Assessment of Dam Safety

Coal Combustion Surface Impoundments (Task 3)

Final Report

American Electric Power
General James Gavin
Power Plant
Cheshire, Ohio

STINGY RUN DAM INSTRUMENT LOCATIONS
GENERAL JAMES GAVIN POWER PLANT
AMERICAN ELECTRIC POWER
CHESHIRE, OHIO

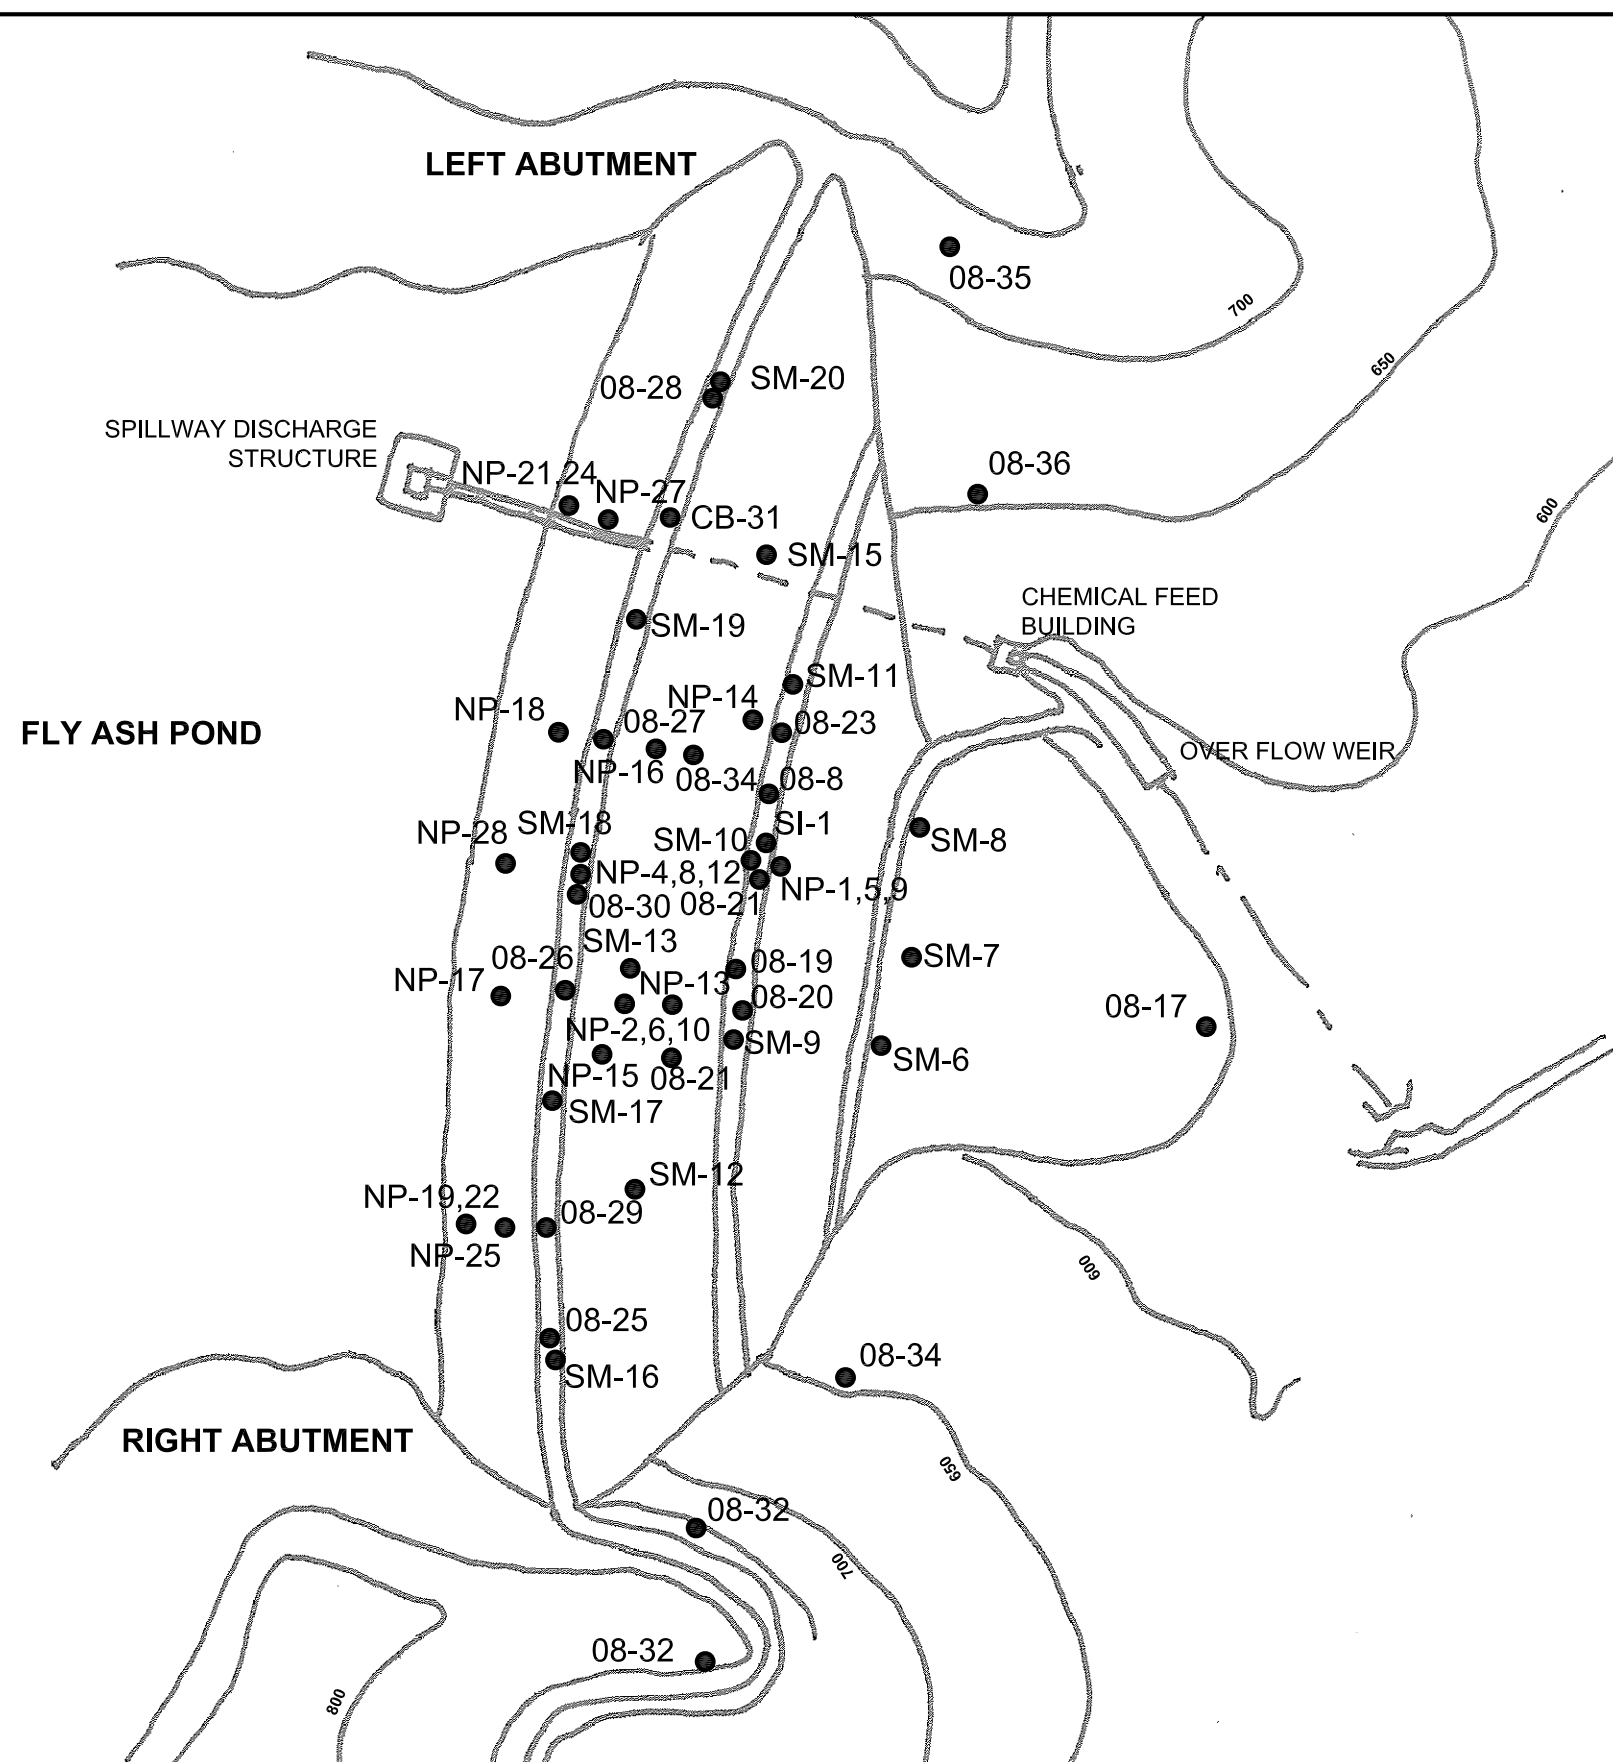
At Stingy Run Dam many piezometers, settlement monitoring monuments, and inclinometers are in place as shown in Figure 7B. The locations shown in Figure 7B represent what was provided to CHA although AEP acknowledged that some of these locations have been destroyed over the years by mowers and vandals. Therefore, this figure should not be considered an accurate depiction of currently operating instrumentation.

We recommend AEP evaluate the need for and/or replace instrumentation that has been destroyed at the Stingy Run Dam. We understand that mower damage and vandals have been a problem at this site. Additional protection may be needed at the instrument locations to protect against this damage.

BOTTOM ASH POND SLOPE STABILITY
OUTBOARD STEADY STATE
GENERAL JAMES GAVIN POWER PLANT
AMERICAN ELECTRIC POWER
CHESHIRE, OHIO

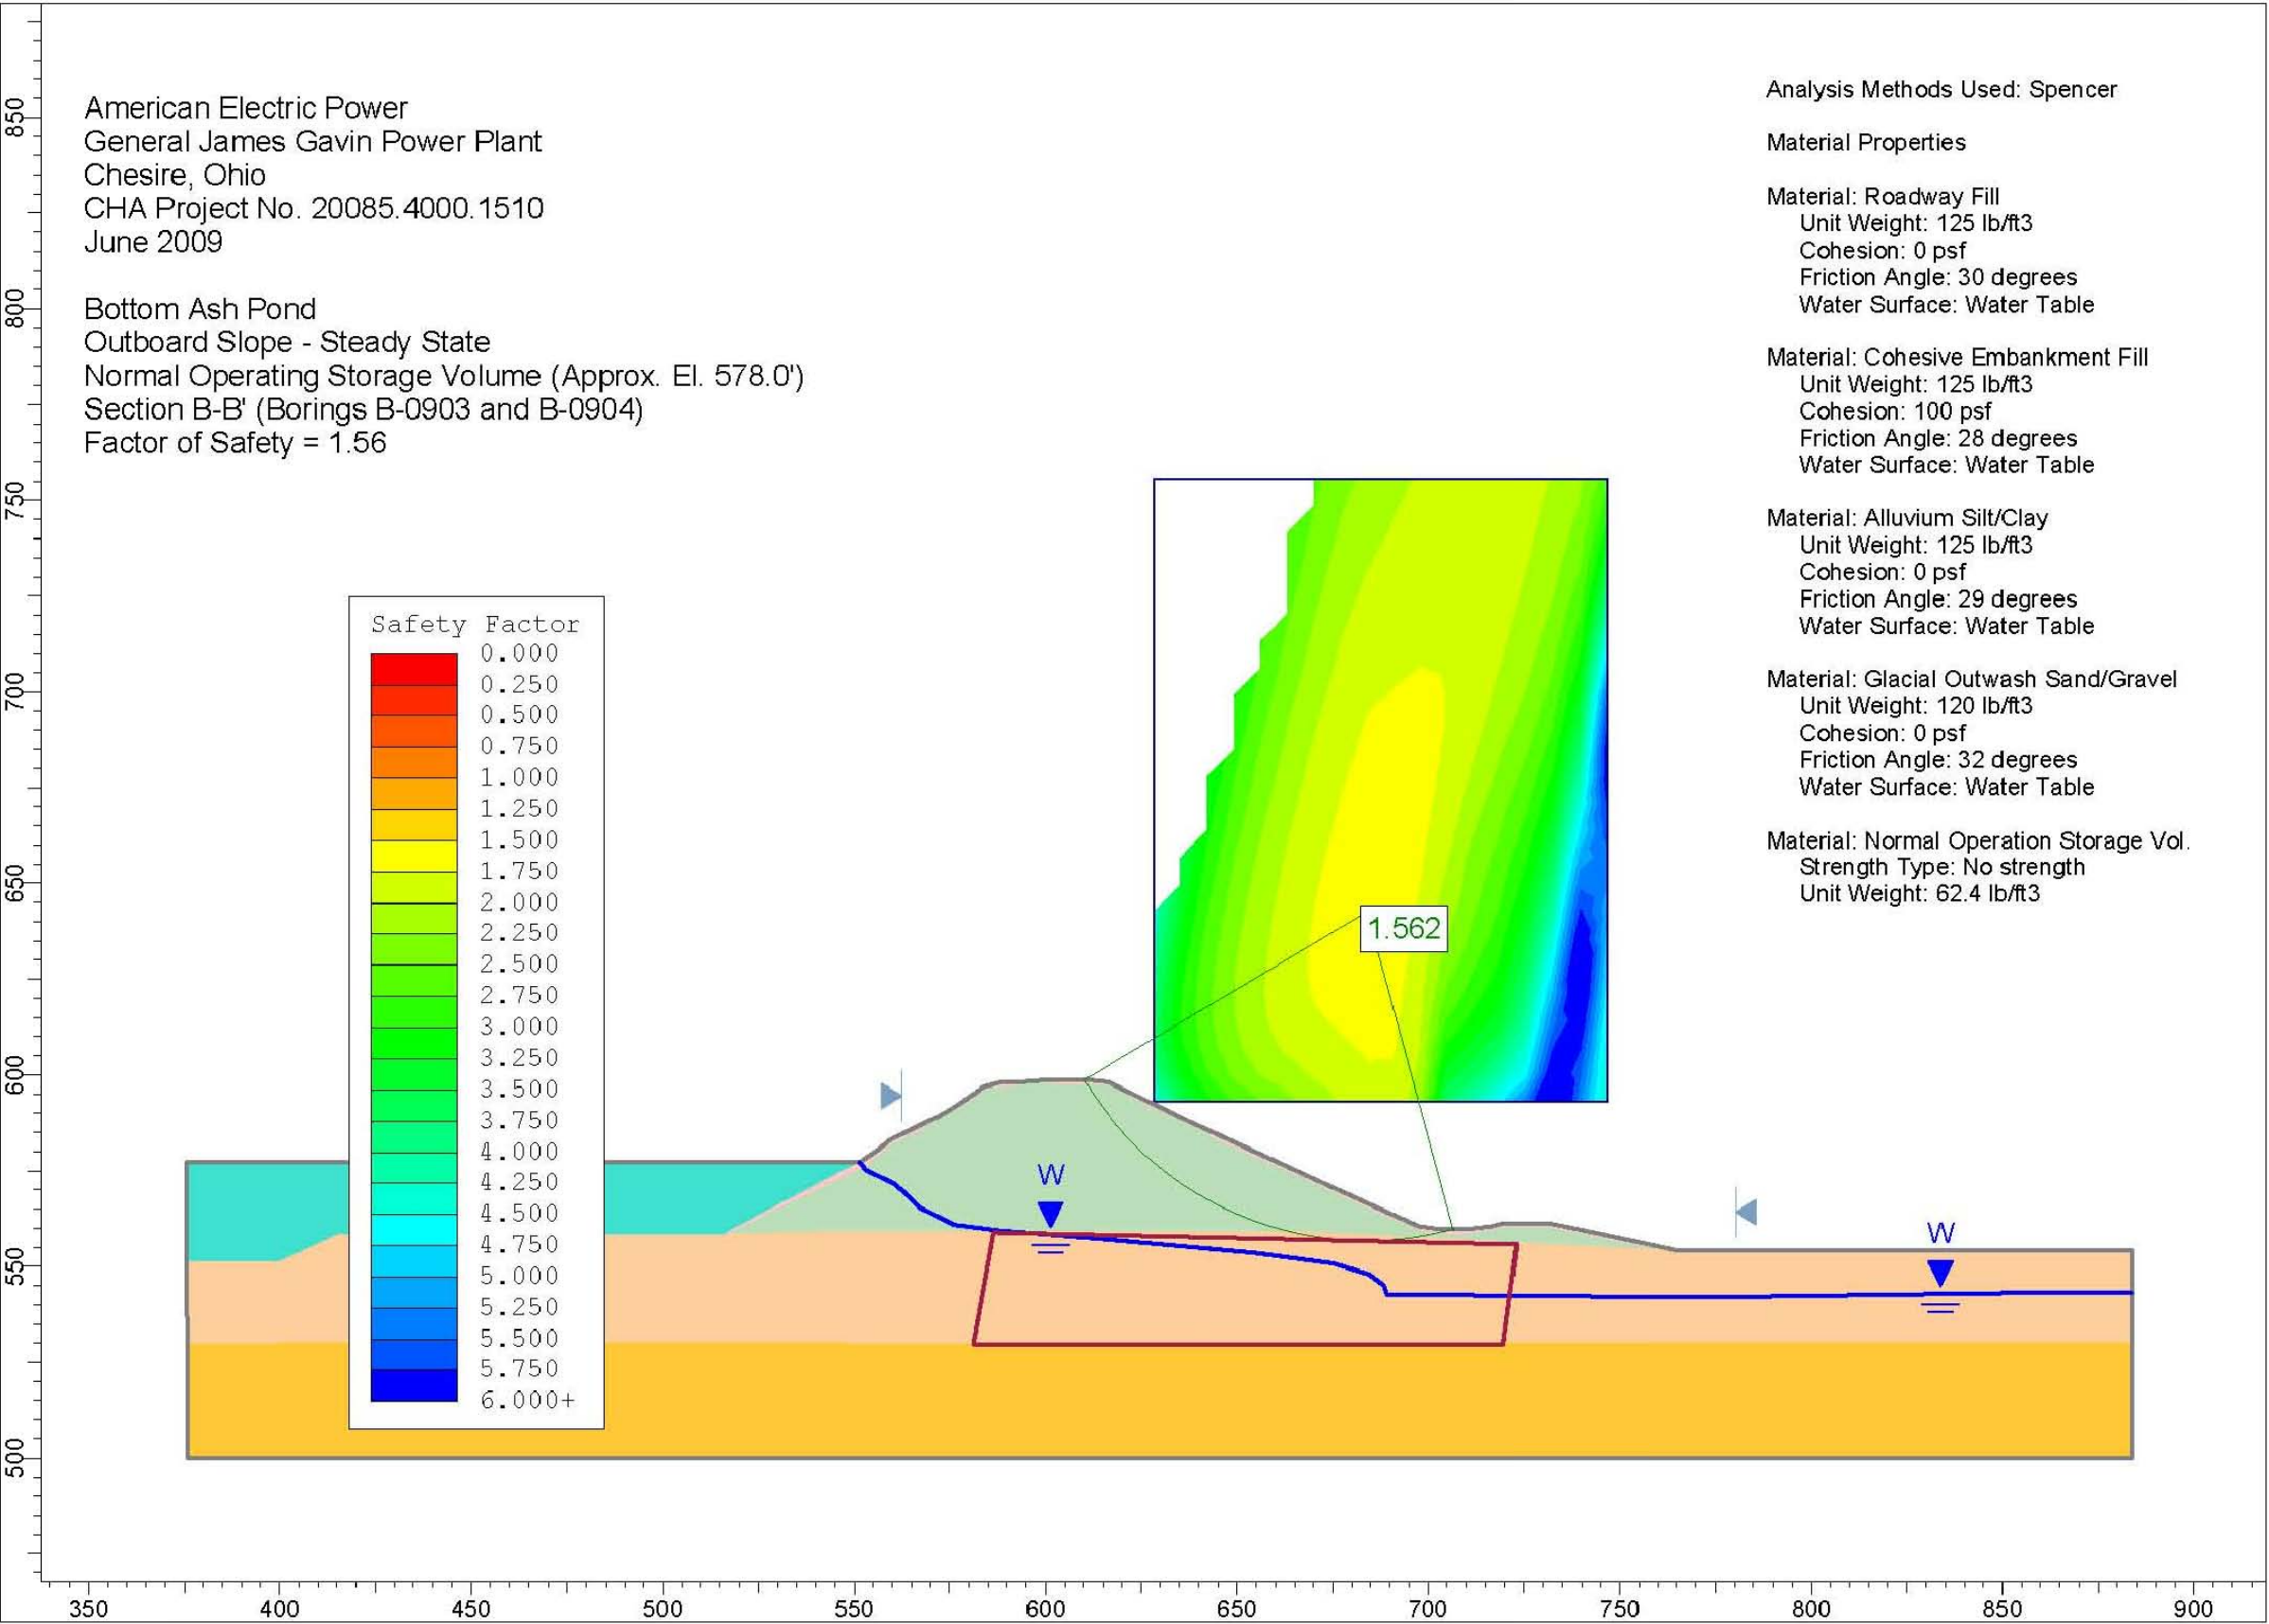
the factor of safety for this load case provided in the report. Our Slide™ output resulted in a similar factor of safety as shown on Figure 9A.

- The downstream slope stability outputs for the steady state load condition for Cross Sections A and B show failure planes within the embankment soils. If the alluvium silt/clay was modeled with a soft layer at the depth corresponding to the low sample effort, the failure plane may actually fall within the alluvium foundation soils and not the embankment soils.

**BOTTOM ASH POND SLOPE STABILITY
INBOARD STEADY STATE**
GENERAL JAMES GAVIN POWER PLANT
AMERICAN ELECTRIC POWER
CHESHIRE, OHIO

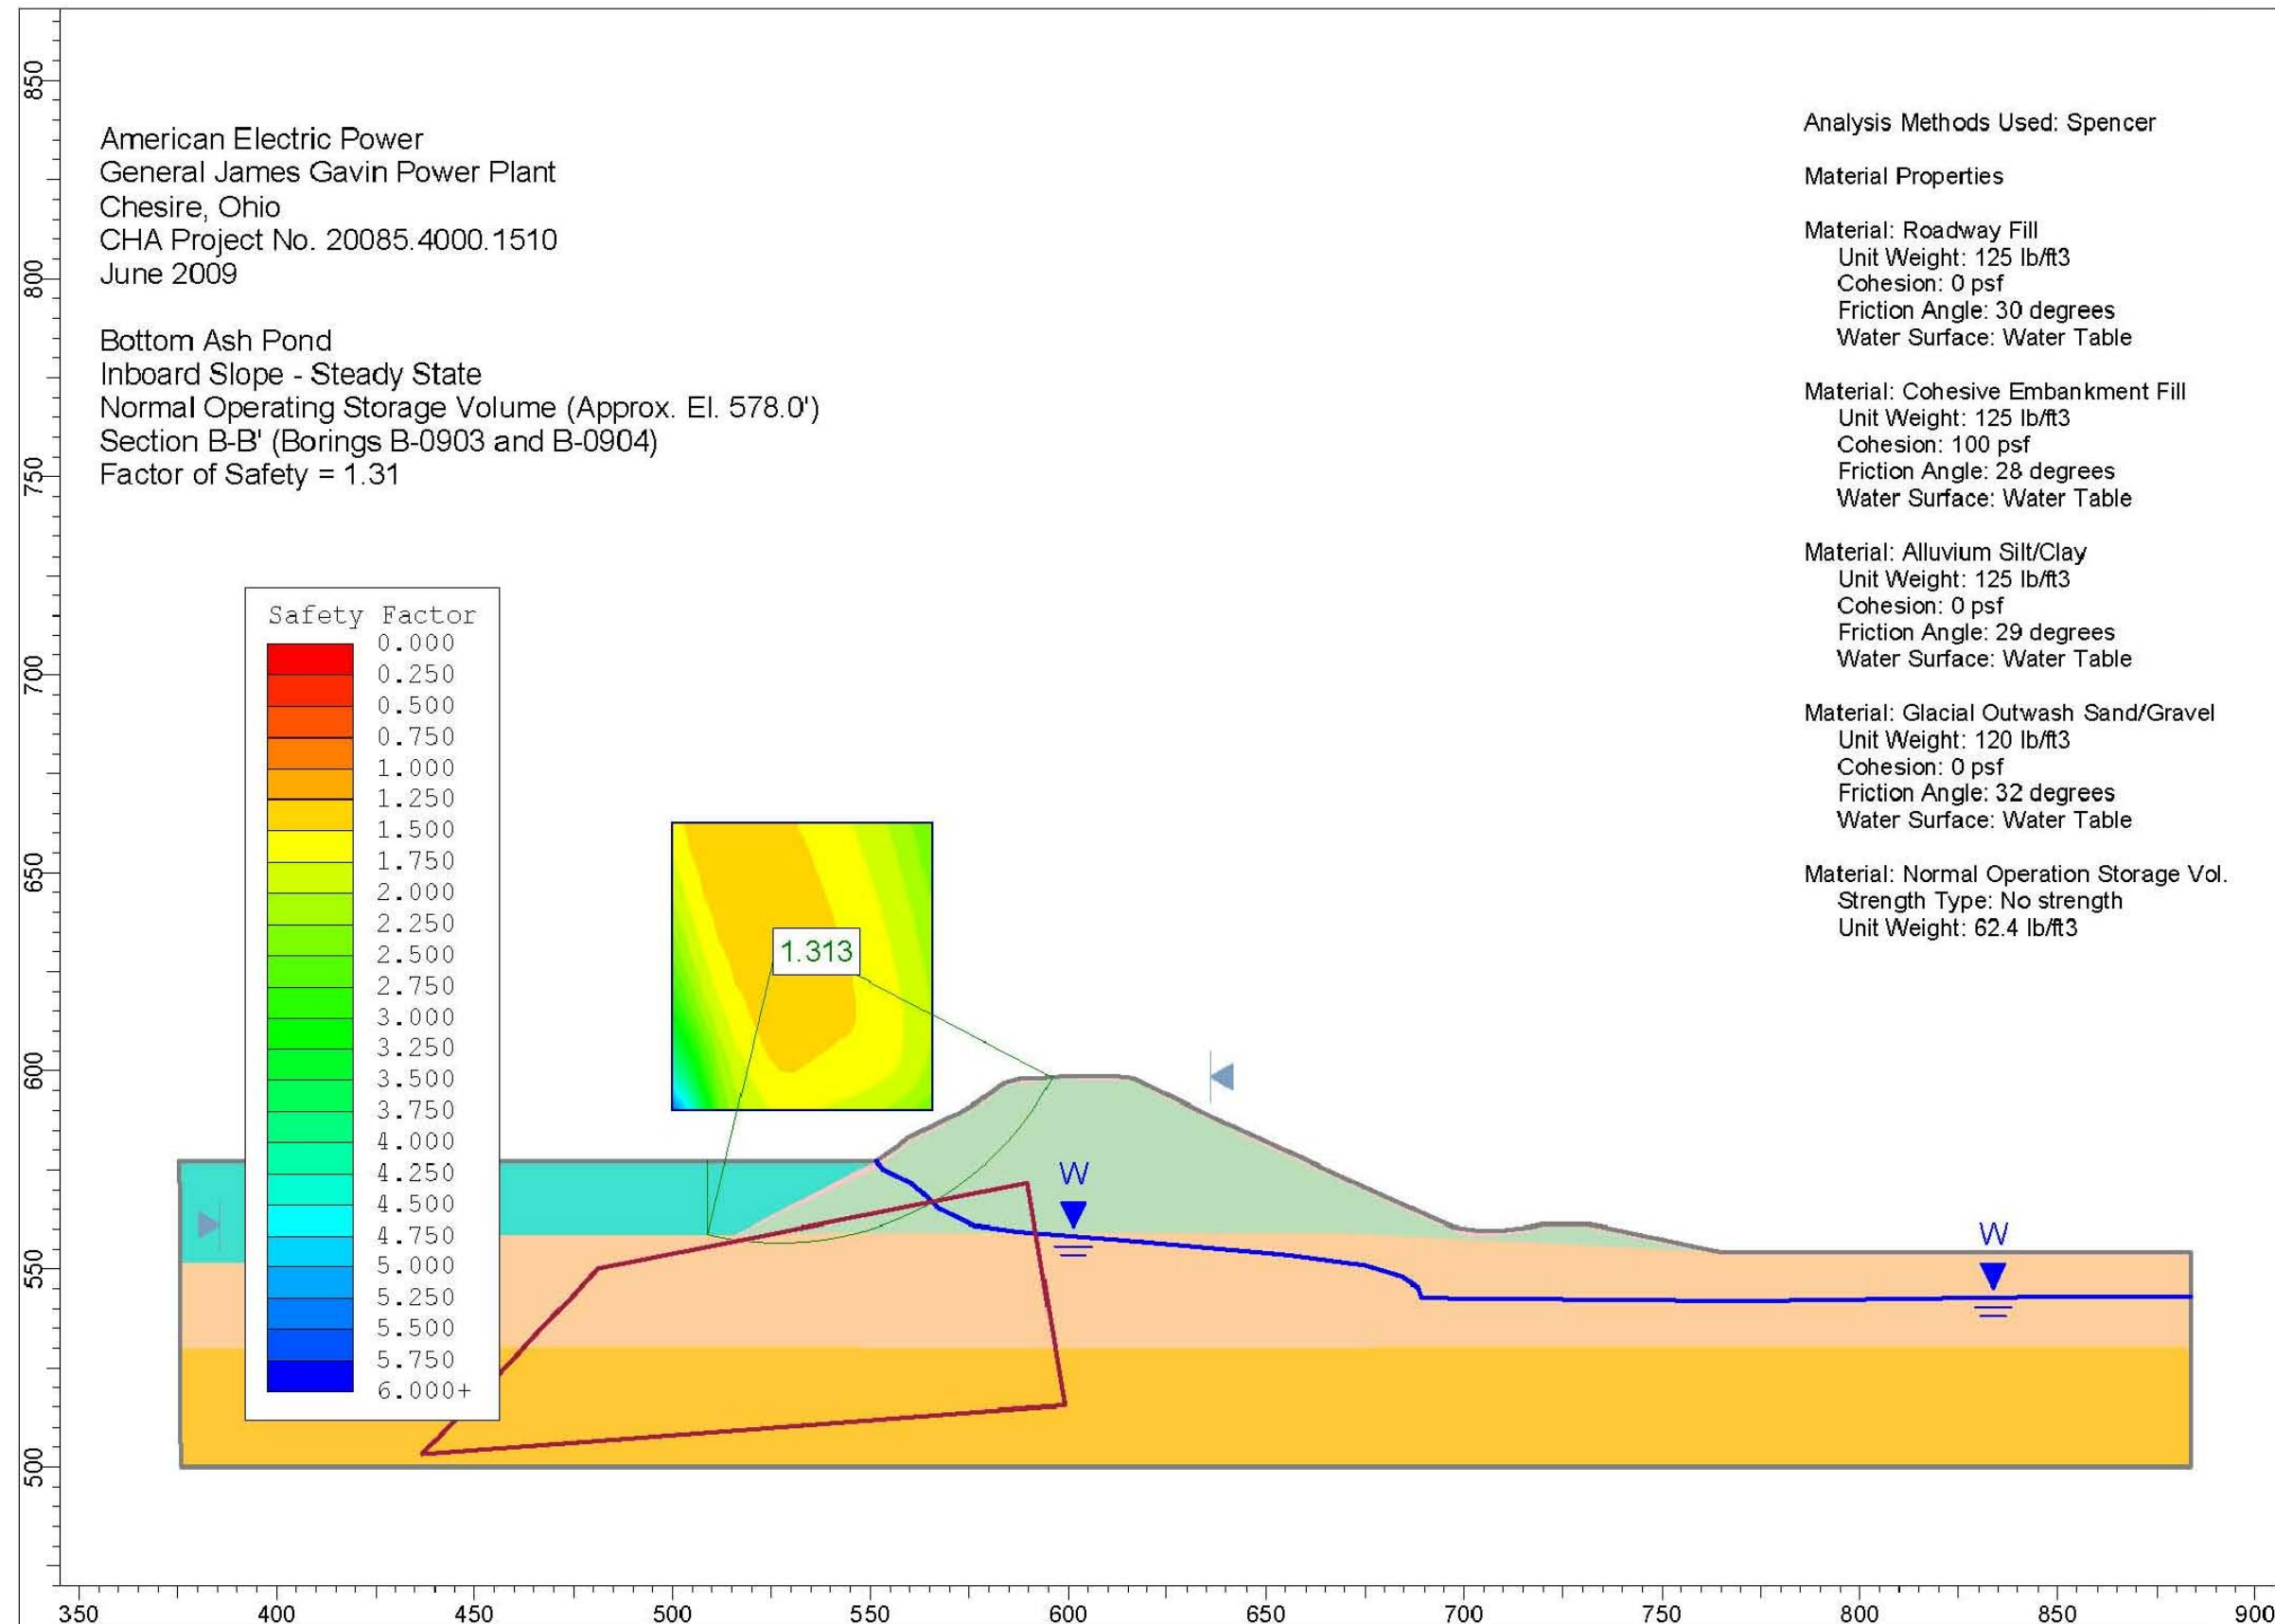
- The factor of safety for the upstream (inboard) embankment slope of the pond was not evaluated as part of BBCM's June 2009 investigation. CHA modeled the upstream slope using the south embankment geometry and the steady state loading condition (see Figure 9B) and the soil parameter provided in BBCM's report. The calculated factor of safety was 1.3 which is below the minimum required factor of safety (according to the USACOE). This factor of safety is in part the result of the over steepened nature of the

CHA recommends the upstream slope be re-graded to correct the steepness and slumped areas for stabilization. This effort should be coordinated with the recommendations made in Section 4.11 to analyze the upstream slope.
